EAST COUNTY SUBSTATION PROJECT

MINOR PROJECT REFINEMENT REQUEST FORM

Date Submitted:	05-17-13 (Originally Submitted) 06-12-13 (Resubmittal) 06-25-13 (Resubmittal)	Request #:	4	
Date Approval Required:	06-28-13	Landowner:]Vj ku'lphto cvkqp'j cu'dggp" tgf cevgf 'f wg'vq'ku'eqphk' gpvkn' pcwtg_"	
APN:]Vj ku'lphto cvkqp'j cu'dggp'tgf cevgf 'f wg'vq'ku'eqphk' gpvkn'pcwtg_			
Refinement from (check all that apply):				
<input type="checkbox"/> Mitigation Measure	<input type="checkbox"/> APM	<input checked="" type="checkbox"/> Project Description	<input type="checkbox"/> Drawing	<input type="checkbox"/> Other
Identify source (mitigation measure, project description, etc.):				
<p>Page C-26 and Figure C-4B in Section C. Alternatives of the Final Environmental Impact Report/Environmental Impact Statement (EIR/EIS) for the East County (ECO) Substation Project (Project) describe and depict the alignment of the main access road to be constructed from Old Highway 80 southeast to the ECO Substation, which is now referred to as the Southern Access Road. Figure C-4B of the Final EIR/EIS depicts the 138 kilovolt (kV) Overhead Transmission Line between the ECO Substation and Old Highway 80, which

SIGHT DISTANCE STUDY – PROPOSED CHANGE

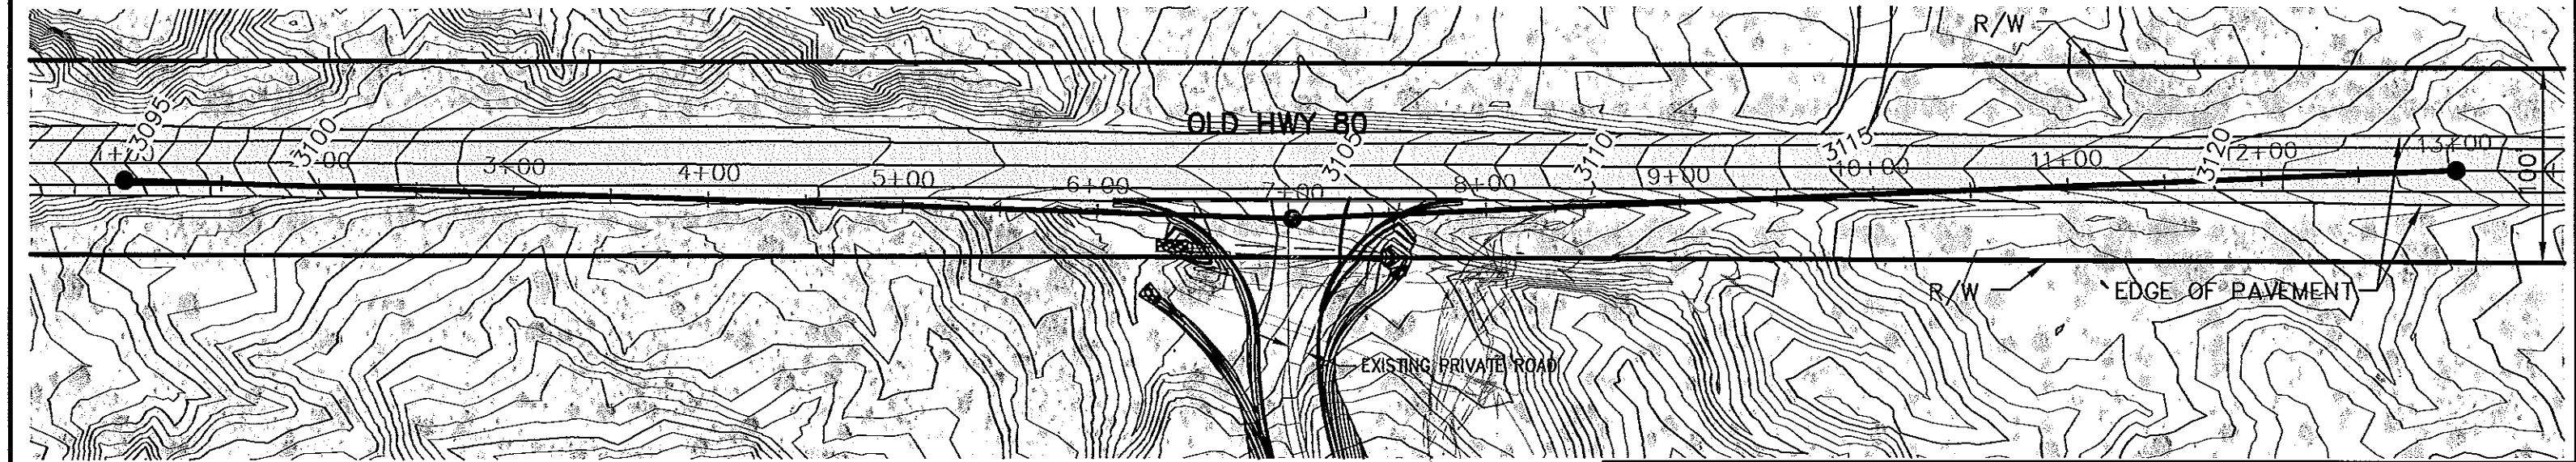
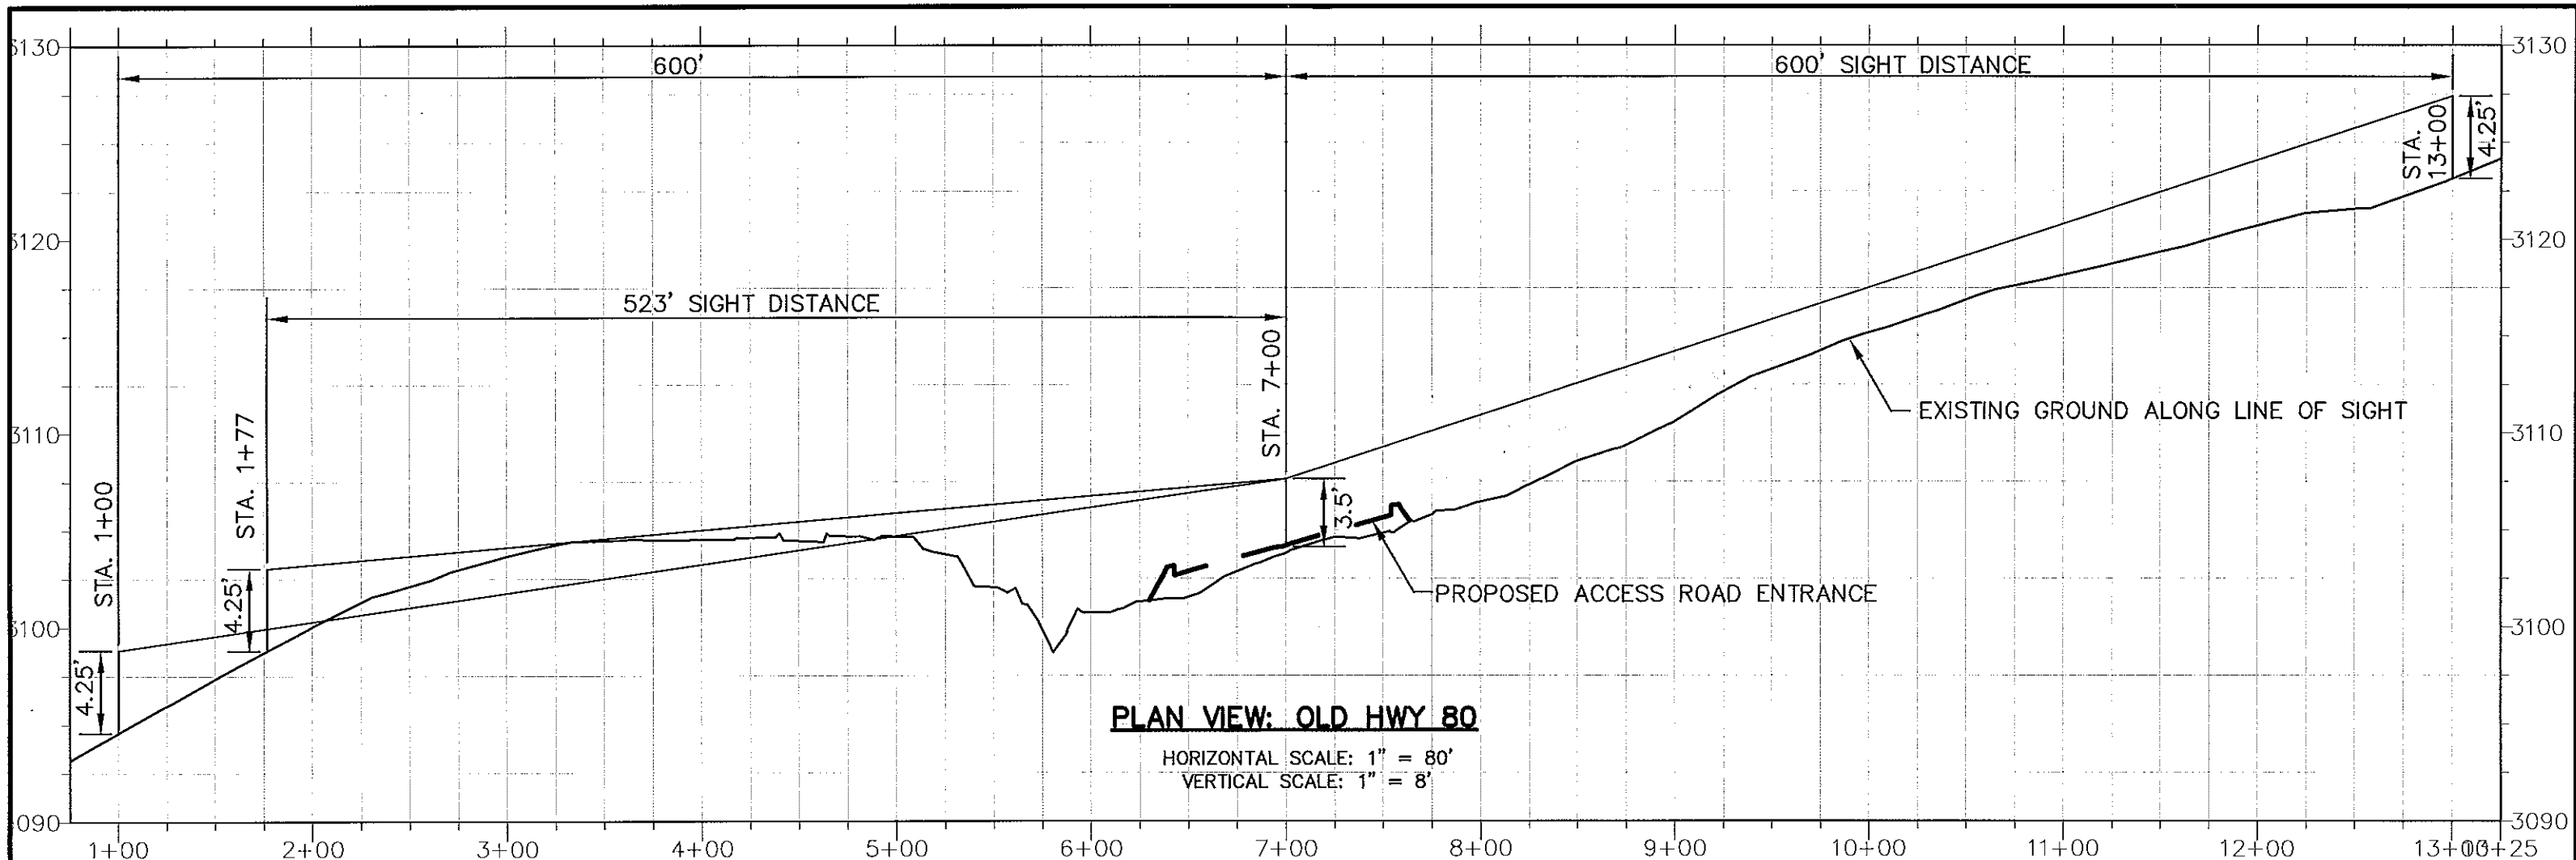
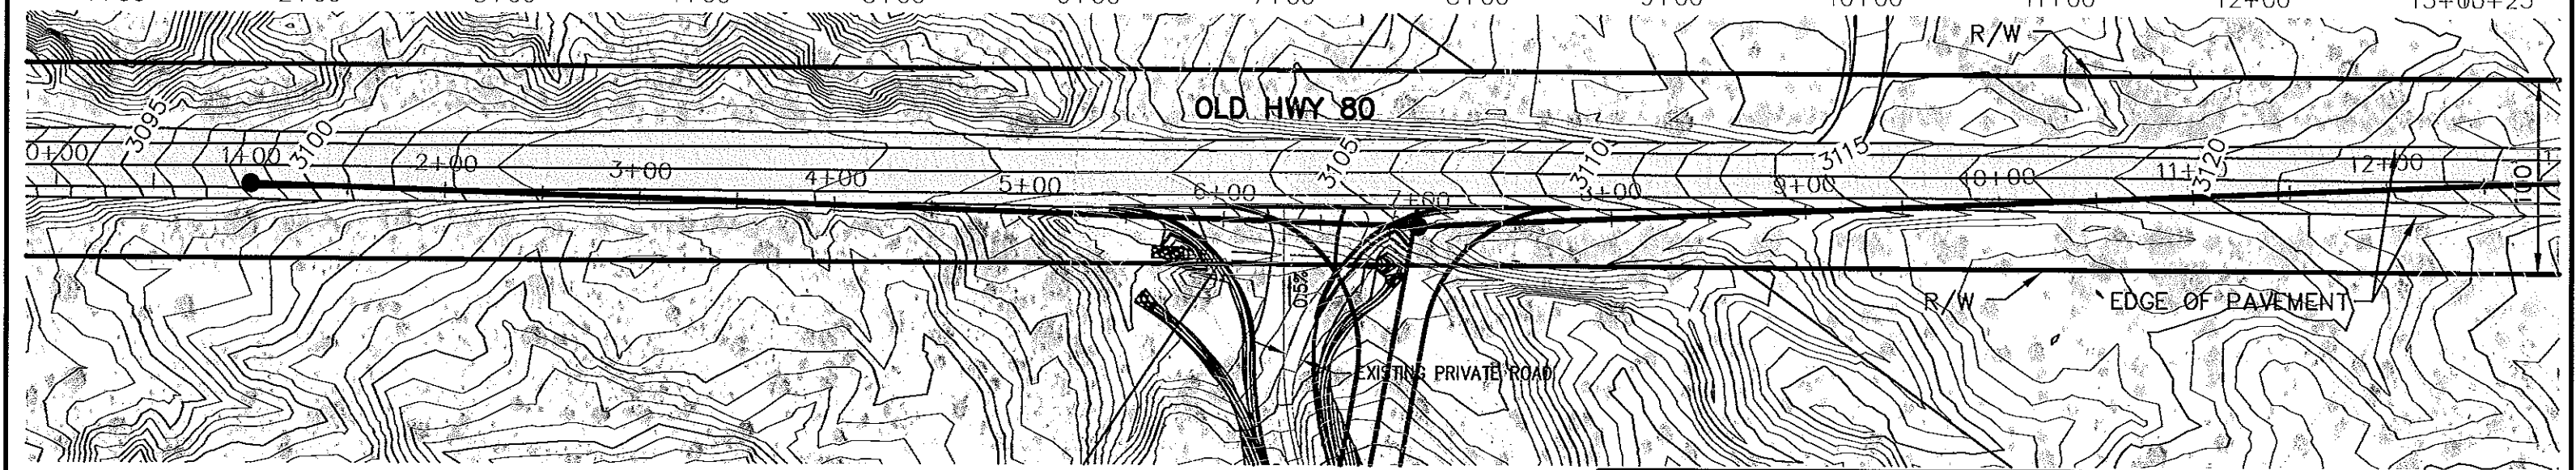
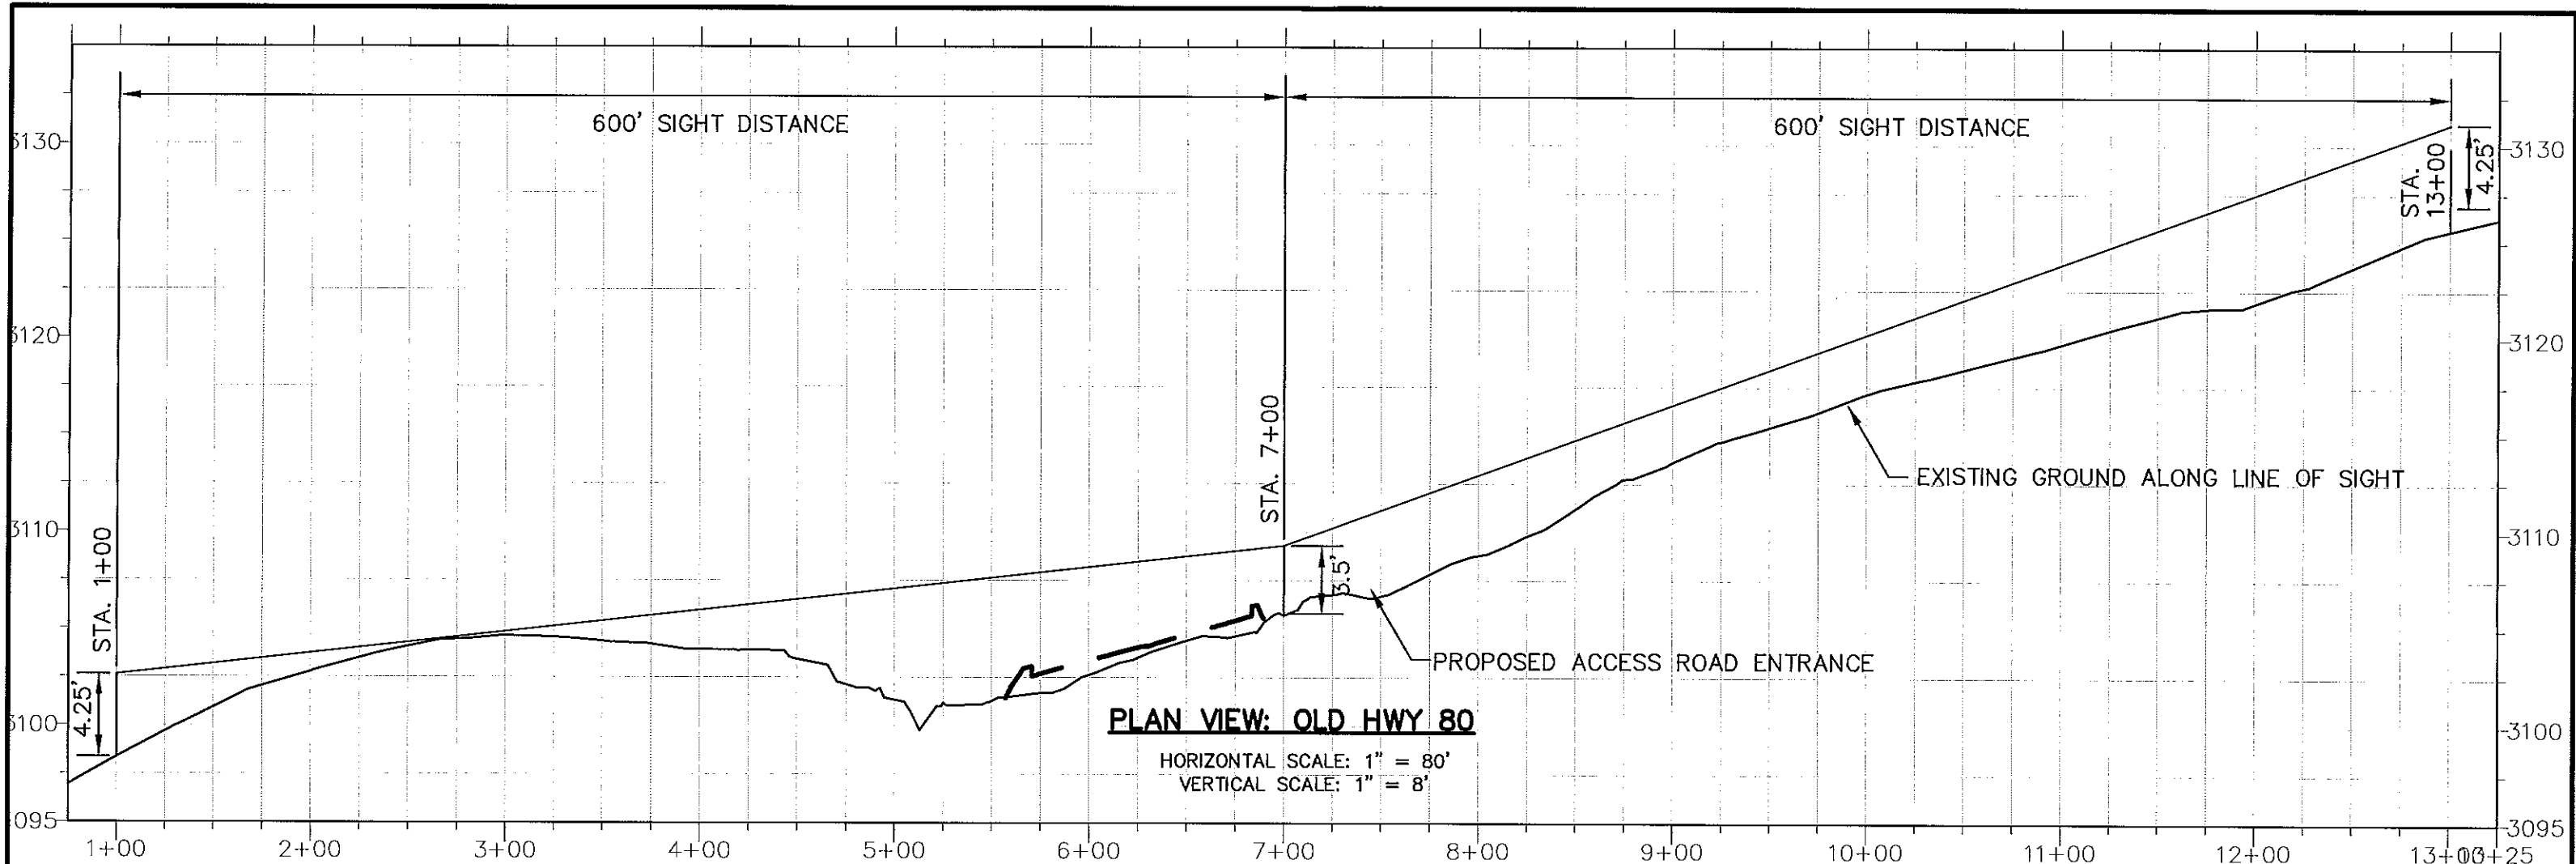
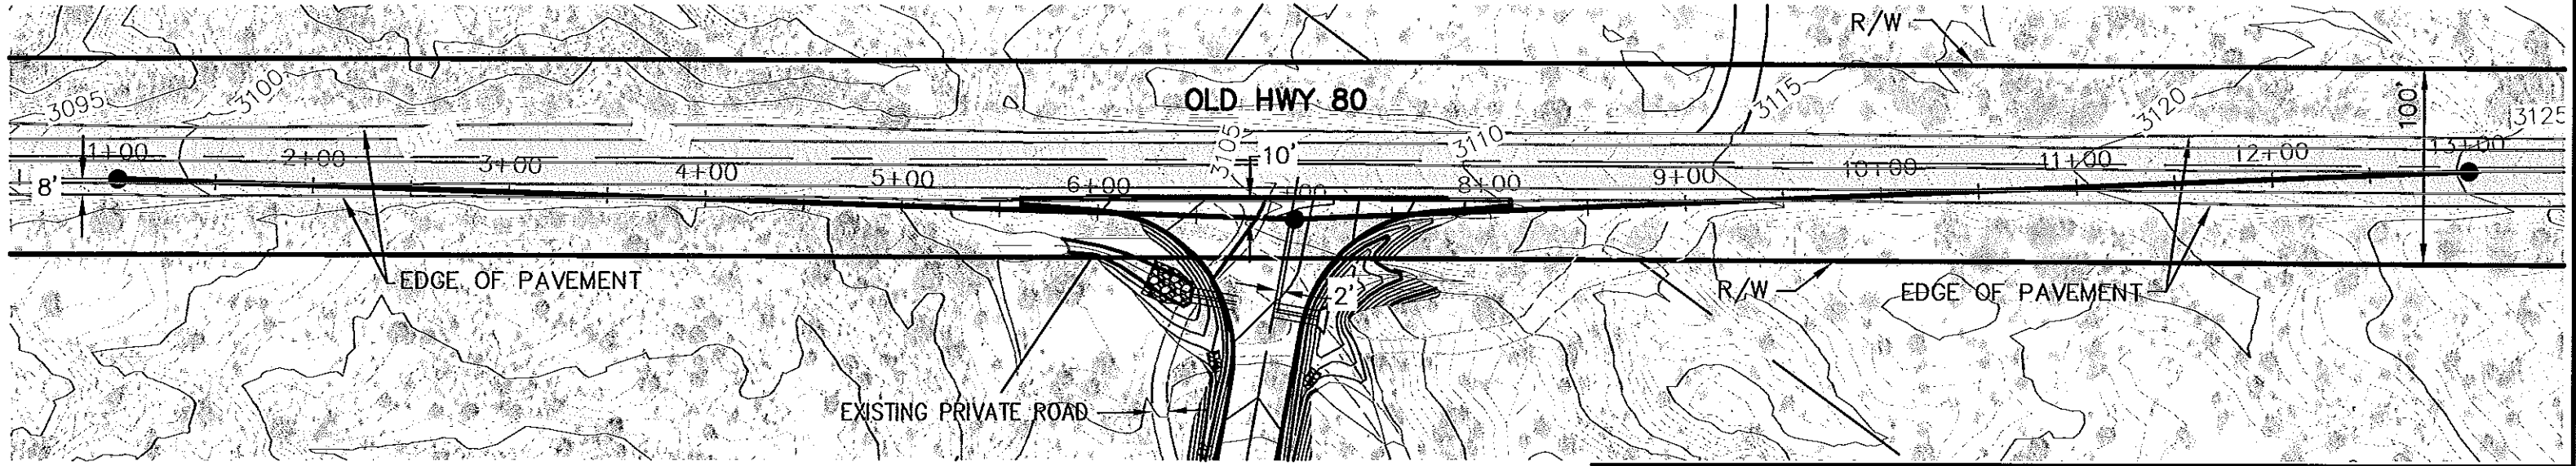
SDG&E submitted copies of the ECO Substation construction plans to San Diego County for review on September 13, 2012. On October 9, 2012, San Diego County requested that an engineer certify that the sight distance would be unobstructed from both directions at the entrance to the Southern Access Road based upon the prevailing operating traffic speed on Old Highway 80, per the Design Standards of Section 6.1.E of the San Diego County Public Road Standards (March 2012). The originally proposed entrance was determined based upon the posted speed limit on Old Highway 80, which is 55 miles per hour. During consultation with San Diego County, SDG&E was advised that the prevailing operating traffic speed on Old Highway 80 is approximately 60 miles per hour. San Diego County Public Road Standards require a minimum corner intersection sight distance of 600 feet for a design speed of 60 miles per hour. SDG&E determined that the originally approved entrance to the Southern Access Road would only provide approximately 523 feet of sight distance in one direction and would not meet San Diego County line-of-sight distance requirements associated with safe entrance onto public roadways. In order to comply with San Diego County Public Road Standards, SDG&E recalculated the location of the entrance and shifted it approximately 70 feet to the northeast to provide the required sight distance and safe access onto the public road. SDG&E then submitted a sight distance letter and exhibit to San Diego County on November 13, 2012, demonstrating compliance with the line-of-sight requirements. Documentation of correspondence with the county, as well as construction plans demonstrating compliance with line-of-sight requirements, is provided as Attachment G: County Correspondence and Line-of-Sight Documentation.

7. A Registered Civil Engineer, Registered Traffic Engineer, or Licensed Land Surveyor shall provide a certified signed statement that, "Physically, there is a minimum unobstructed sight distance in both directions along Old Highway 80 from the private access road serving the substation, for the prevailing operating traffic speed on Old Highway 80 per the Design Standards of Section 6.1.E of the County of San Diego Public Road Standards (dated March 2012), to the satisfaction of the Director of Public Works. If the lines of sight fall within the existing public road right-of-way, the engineer or surveyor shall further certify that, "Said lines of sight fall within the existing right-of-way and a clear space easement is not required."
